DA RECONSIDERATION AMENDMENT - OCTOBER 2025

PROJECT
17-21 UNIVERSITY AVENUE & 24 MARCUS CLARKE STREET,
CANBERRA, ACT

DRAWING TITLE
BUILDING A SHORT SECTION 1,2 & 3
SCALE
As indicated @ A1
DATE
OCTOBER 2025

DRAWING NUMBER
ADA.09.01

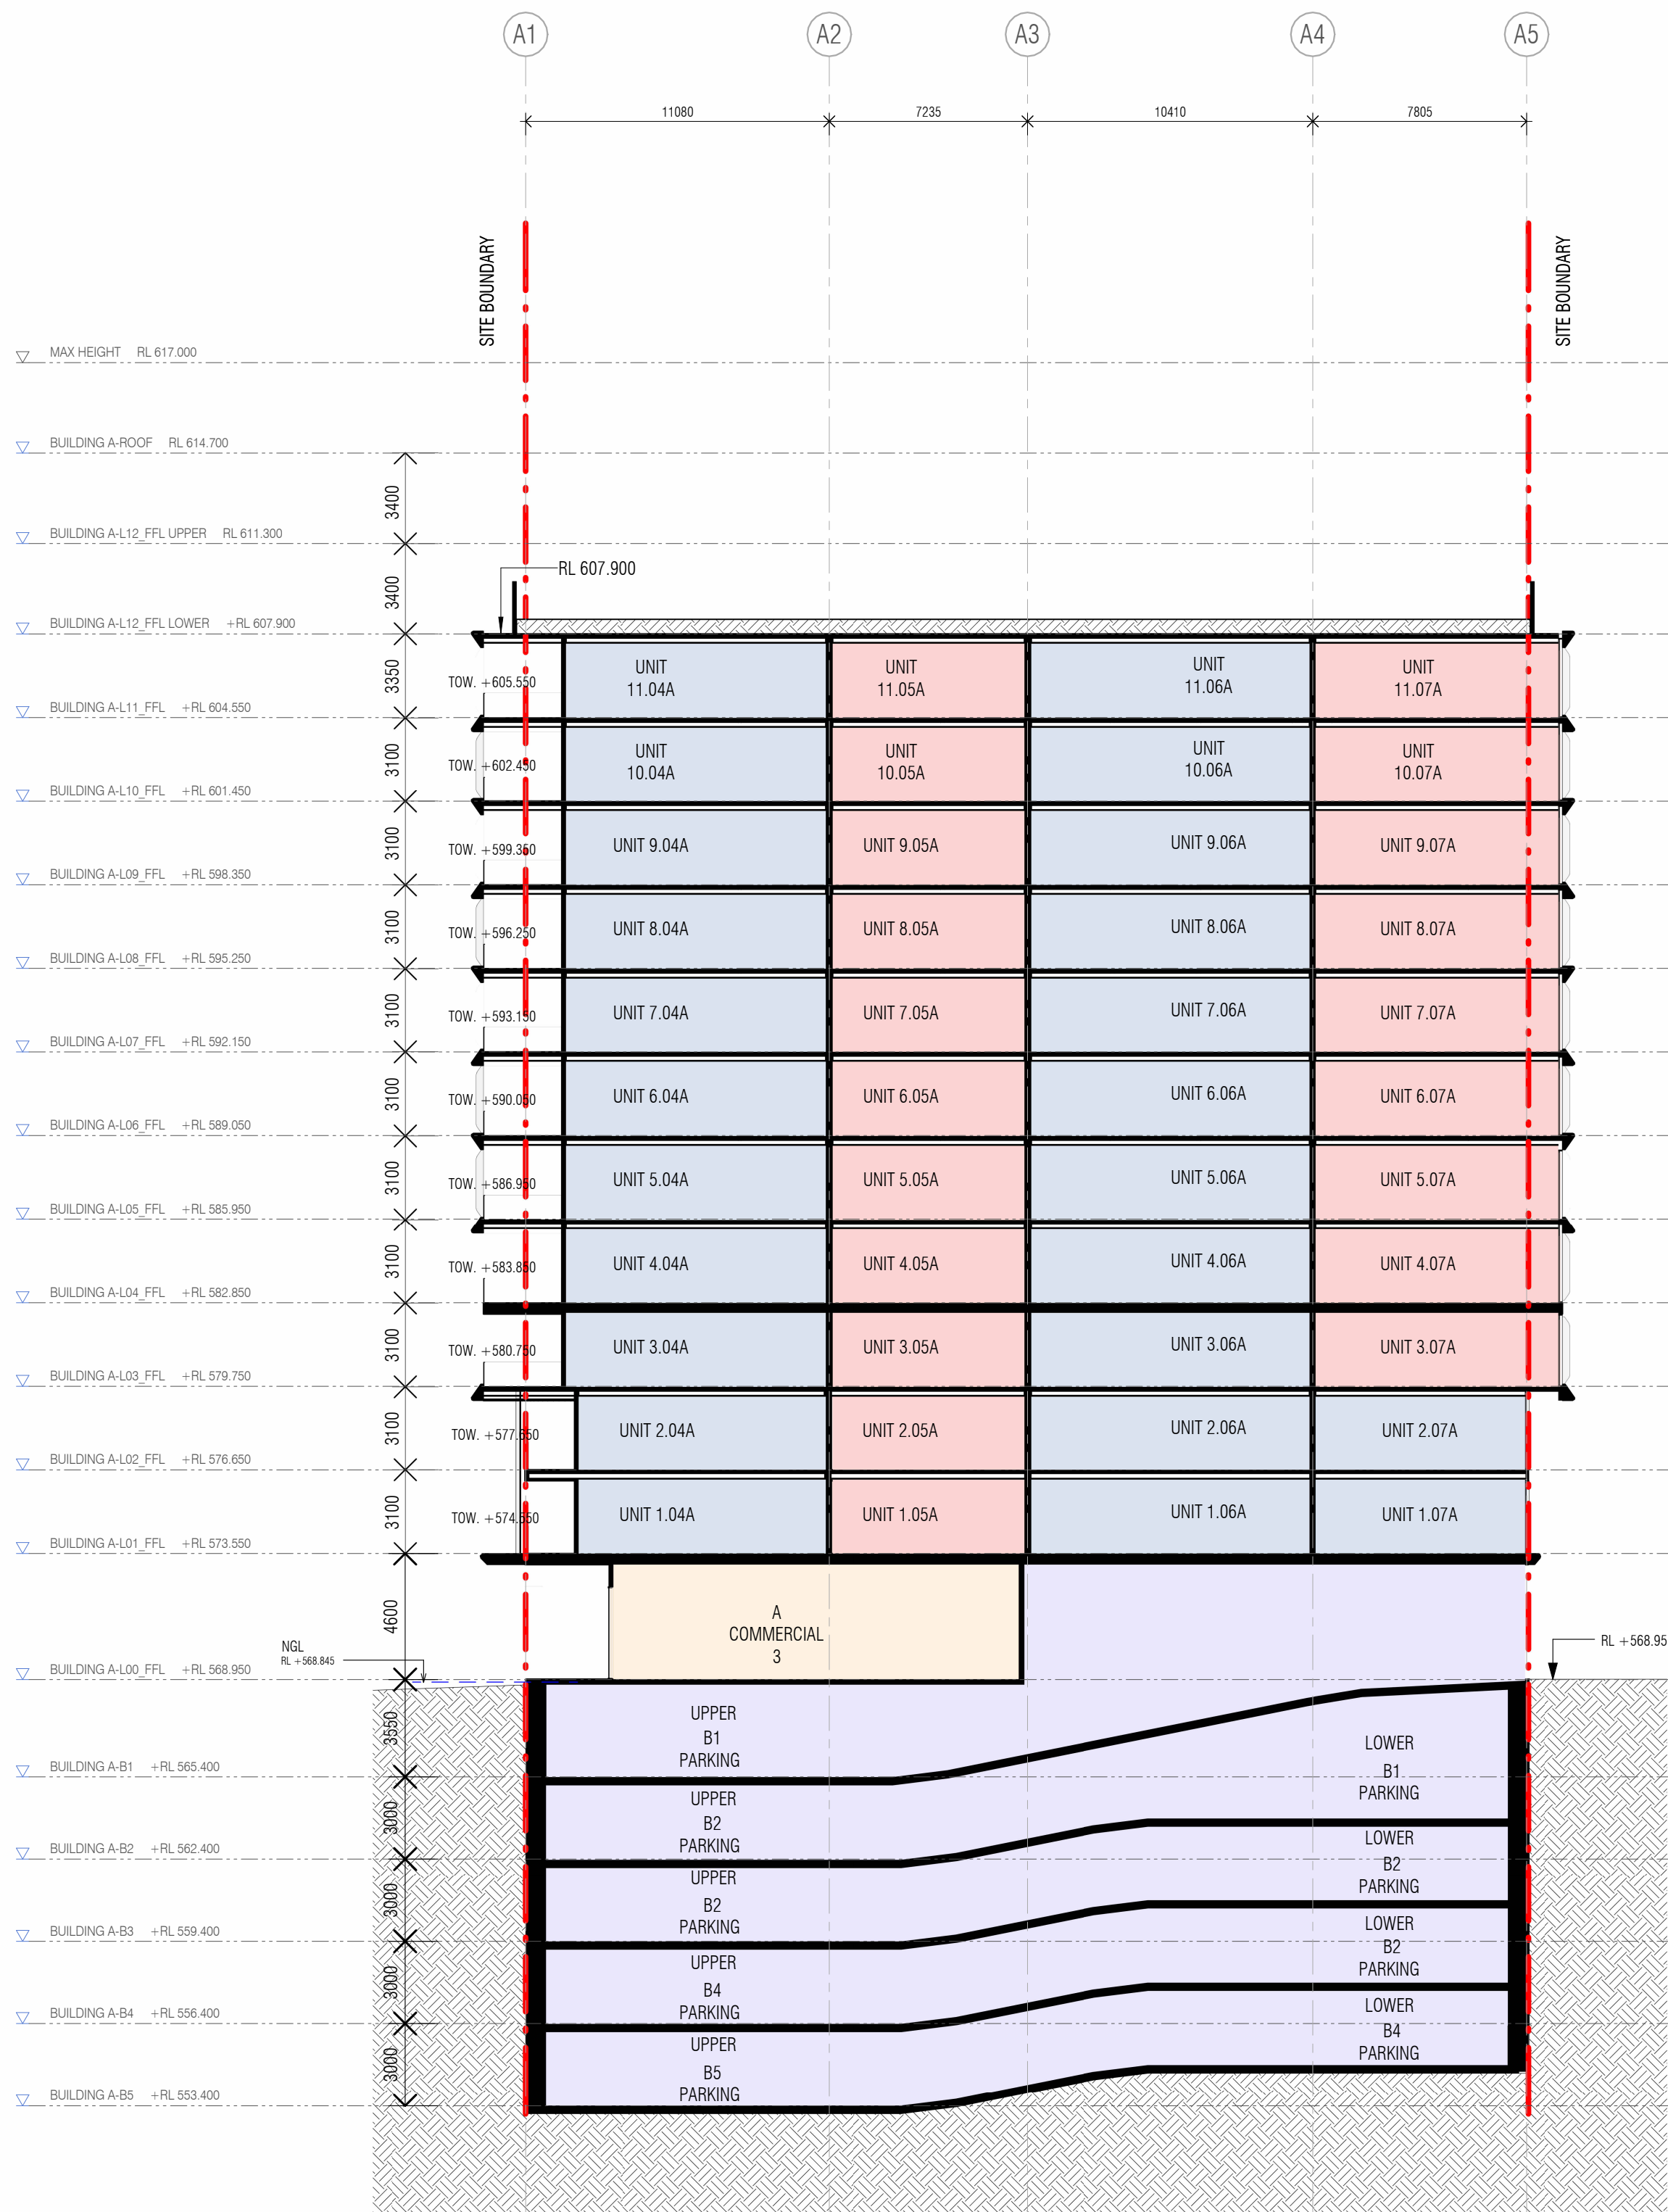
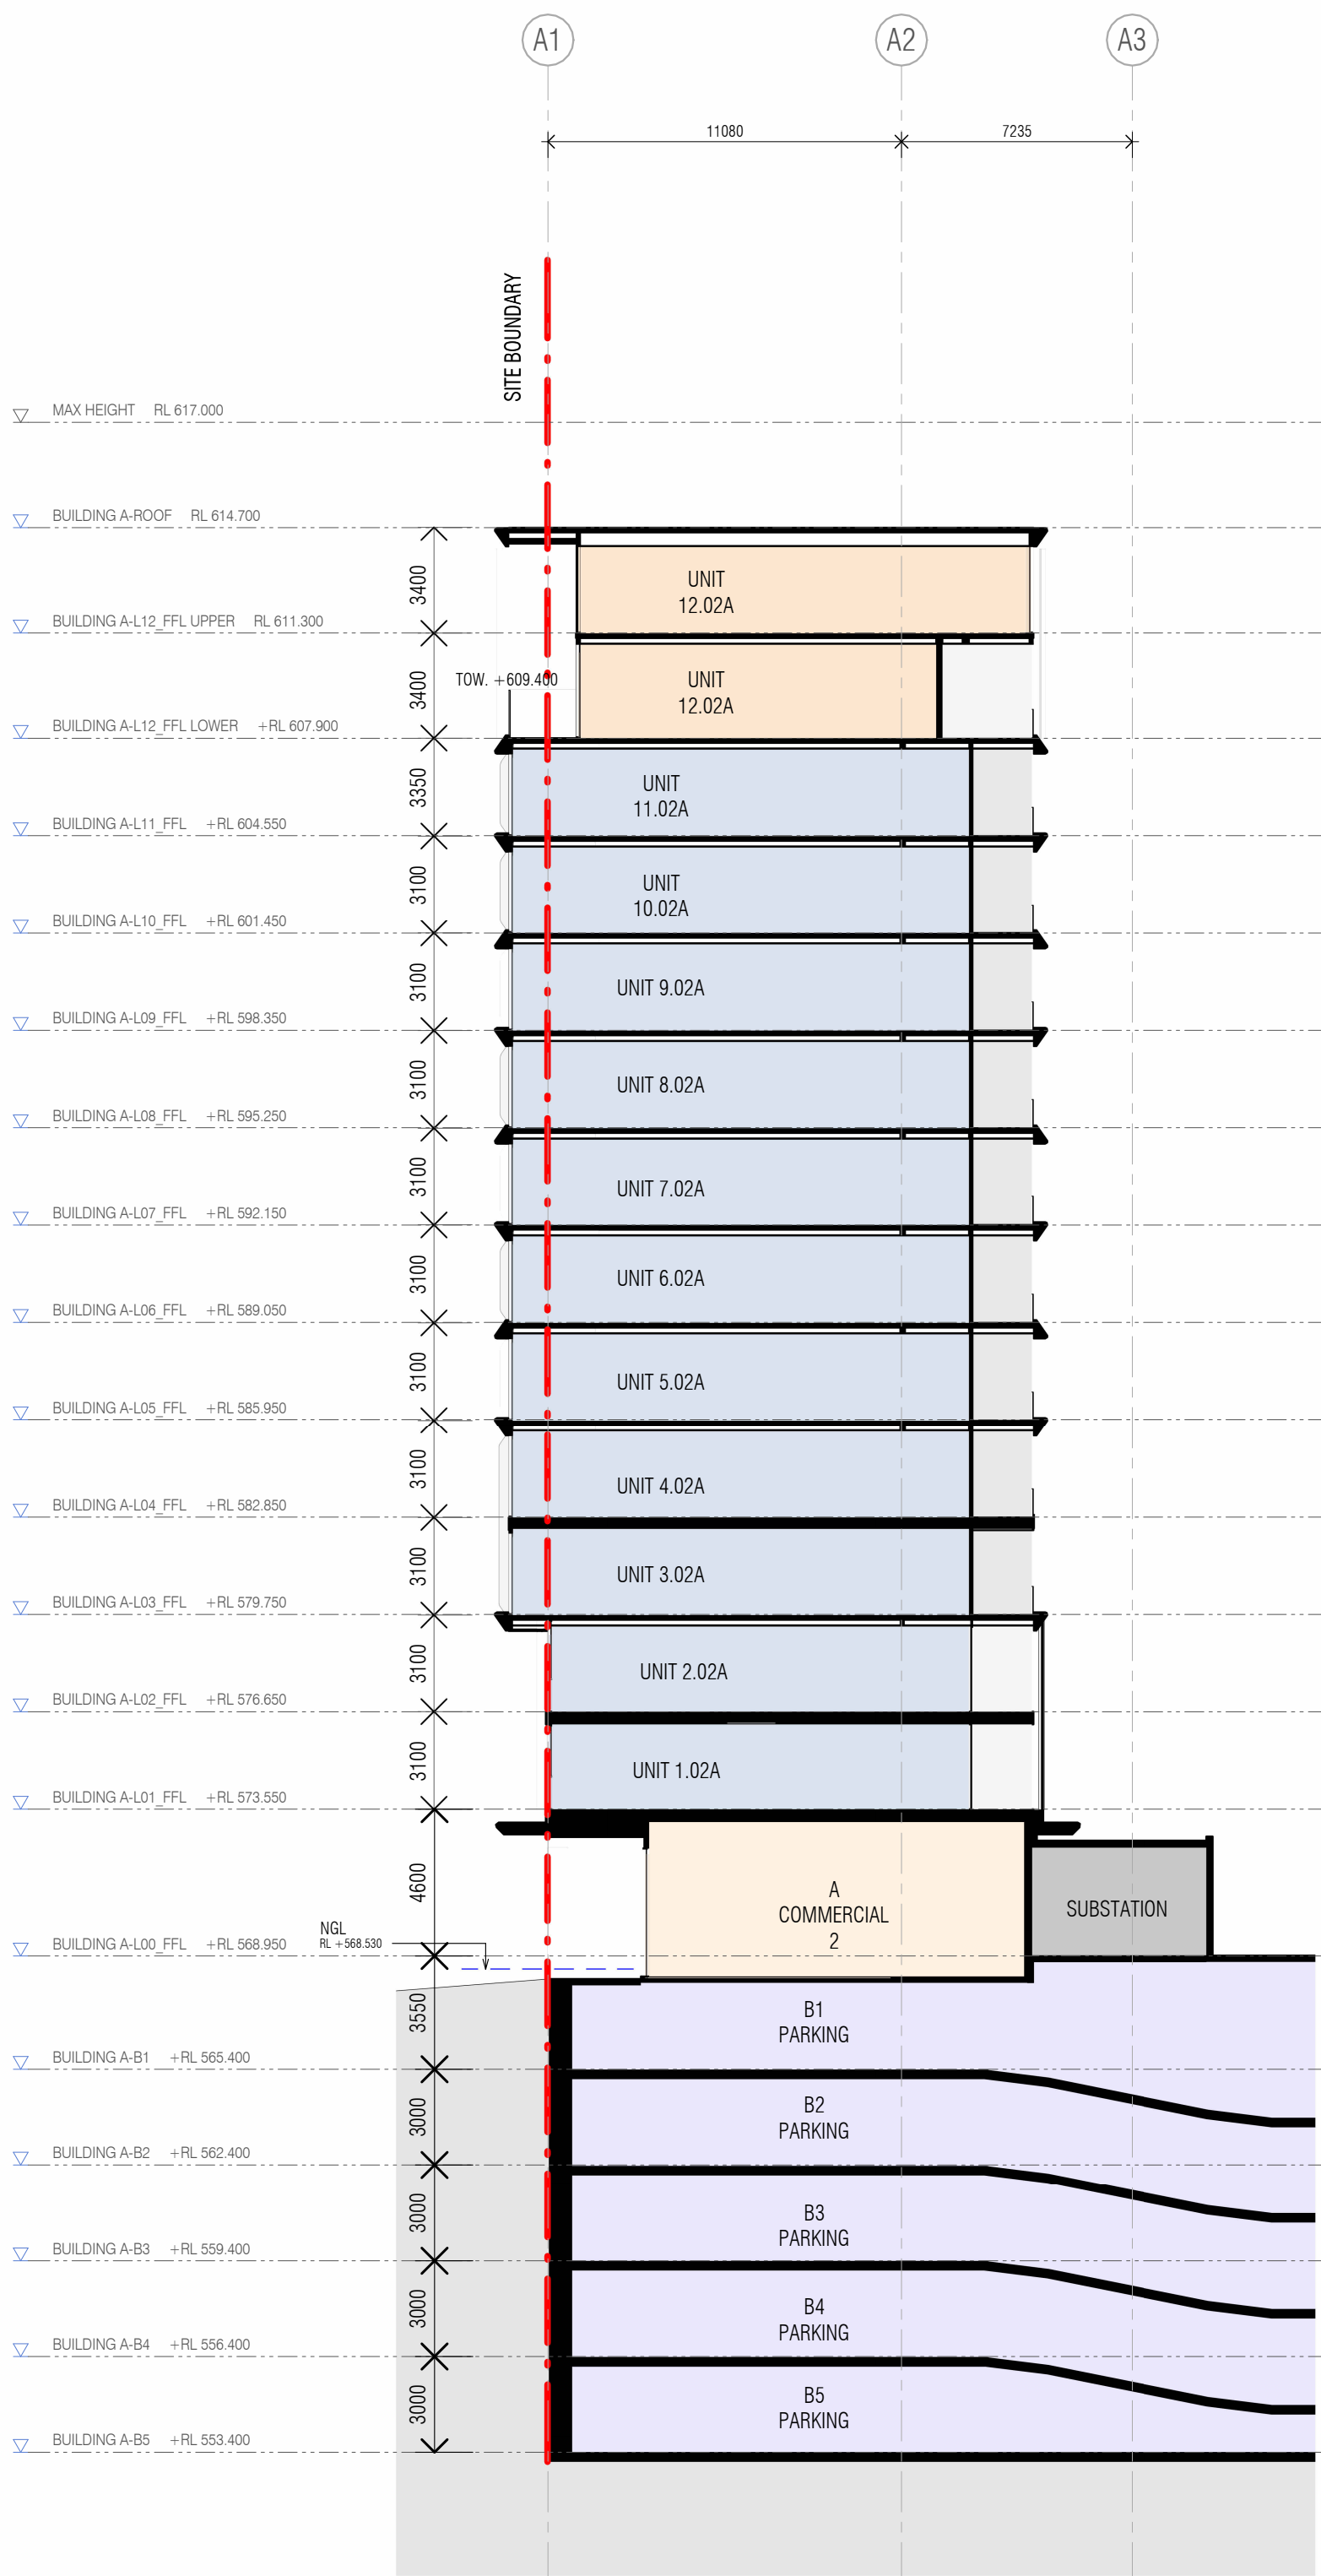
01. UPPER LEVEL CHANGES

- OVERALL HEIGHT OF BUILDING A REDUCED AND BUILDING B INCREASED TO ALIGN WITH AUTHORITY DISCUSSIONS
- COMMON ROOFTOP GARDEN ADDED TO BUILDING A ADDRESSING UNIVERSITY AVENUE
- BUILDING FACADES DESIGN IMPROVEMENTS
- UNIT PLANS UPDATED AND UNIT MIX AMENDED
- RECONFIGURATION OF BUILDING CORE THROUGHOUT THE UPPER LEVELS
- WINTER GARDENS REMOVED AND REPLACED WITH DEDICATED BALCONY SPACES
- UPPER LEVEL ENCROACHMENTS CONTAINING GFA REMOVED FROM UNIVERSITY AVENUE FRONTAGE
- SOLAR ACCESS TO UNITS MAXIMISED AND DEMONSTRATED

02. GROUND FLOOR CHANGES

- AWNING ADDED TO UNIVERSITY AVENUE
- GROUND FLOOR COMMERCIAL LEVELS ADJUSTED TO EXISTING VERGE LEVELS AND REDUCE STAIRS
- LEVELS ADJUSTED IN THE CENTRAL LANDSCAPE SPACE FOR ACCESSIBILITY
- SERVICE LOCATIONS UPDATED TO SUIT SERVICE LOCATIONS
- INCREASE TO LANDSCAPE AREAS
- UPDATE TO WASTE ROOMS WASTE COLLECTION STRATEGY
- ON GRADE PARKING ALONG DARWIN REMOVED AND RELOCATED TO THE UPPER BASEMENT LEVEL

03. BASEMENT LEVEL CHANGES

- EXTENT OF BASEMENT 5 REDUCED WHILST MEETING THE CARPARKING RATES
- RECONFIGURATION OF BUILDING CORE AND RATIONALISATION OF BASEMENT RAMPS
- RECONFIGURATION OF BUILDING SERVICES AS PER ADVICE RECEIVED
- VISITOR PARKING ADDED TO BASEMENT LEVELS, INCLUDING RELOCATION OF EXISTING CARPARKING ON DARWIN PLACE PROPOSED FOR REMOVAL
